## **ADDENDUM SUMMARY**

Addendum #5

Project: 2024 – Fishers Elementary School Addition & Renovations

## Request for Information / Responses- 2/14/24

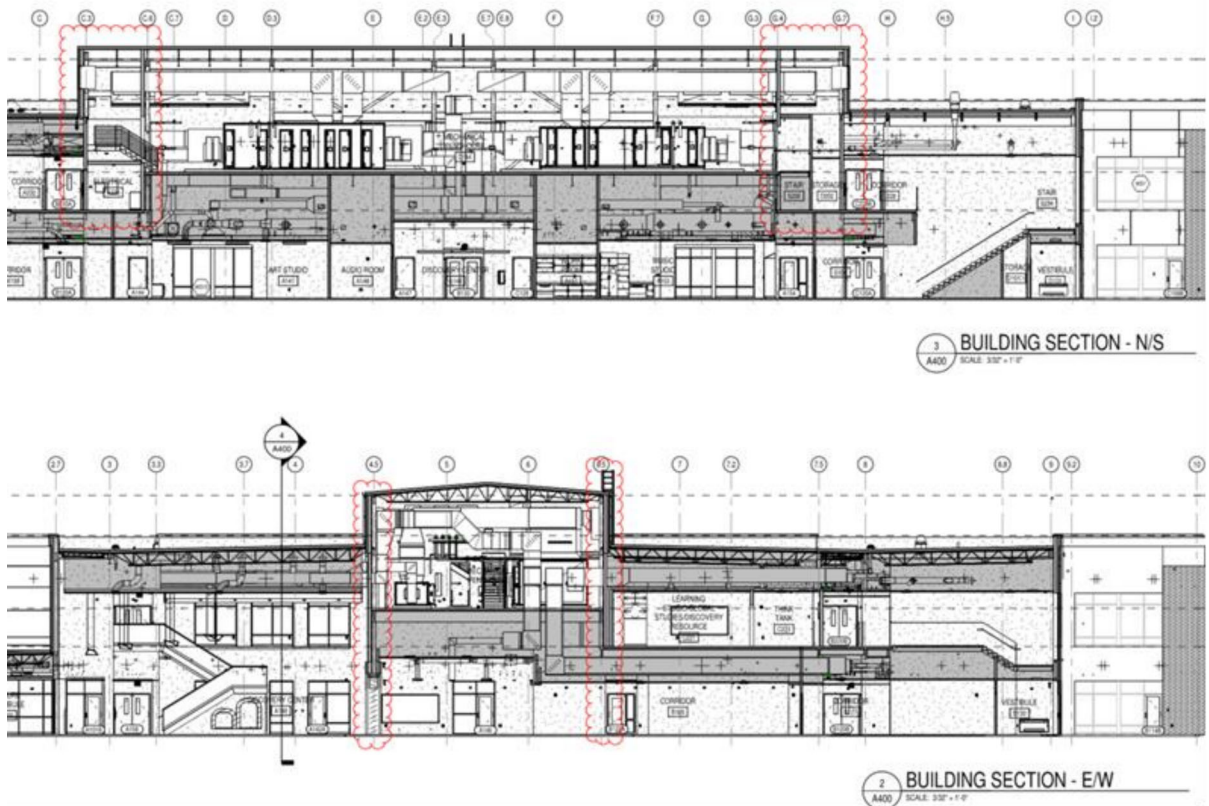
37. Please provide a wall section cut of all sides of the penthouse. From first floor to Mezz roof. See drawing sheet A400 Overall Building Sections. (See Below)
